TRUCK UTILITY LTWT MC2 LANDROVER (110) - ALL TYPES
STOWAGE BIN DRAIN HOLES AND FITTING MODIFICATION RECORD PLATE

MODIFICATION INSTRUCTION

1. This instruction details the drilling of drain holes in the stowage bins of the subject vehicles to allow water drainage and the fitting of a modification record plate to the driver's seat base.

FIG 1 - SIDE VIEW R/H REAR PANEL

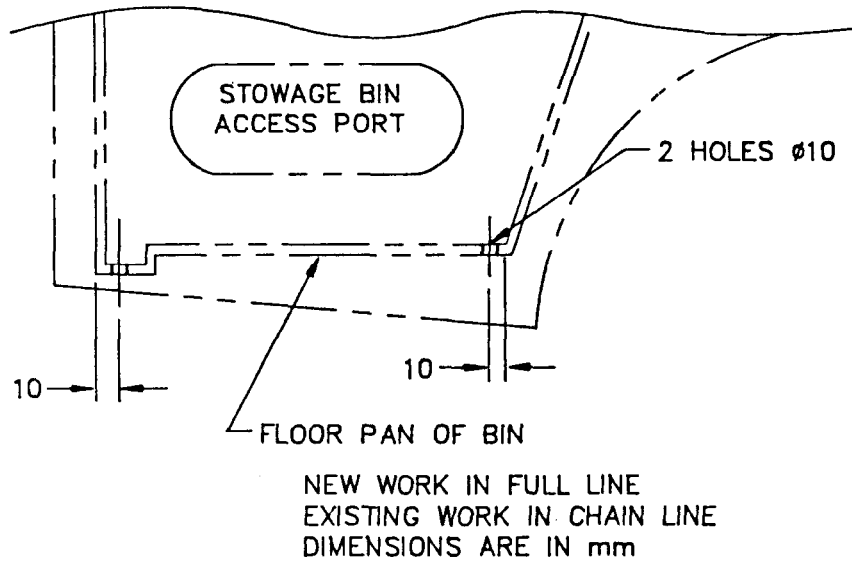
7. The modification is to be carried out as described below:
 - a. Remove the contents of the stowage bins, including the timber floor panels.
 - b. Drill two, 10mm diameter holes in each stowage bin as shown in Figs 1 and 2.
 - c. Position the modification record plate, (item 1 from Table 1) as shown in Fig 3.
 - d. Drill four 1/8 inch diameter holes through the modification record plate and the drivers seat base.
 - e. Using suitable 1/8 inch diameter pop rivets, secure the record plate in position.
8. Modification Record Plate. Deface the numeral 1 on the modification record plate.
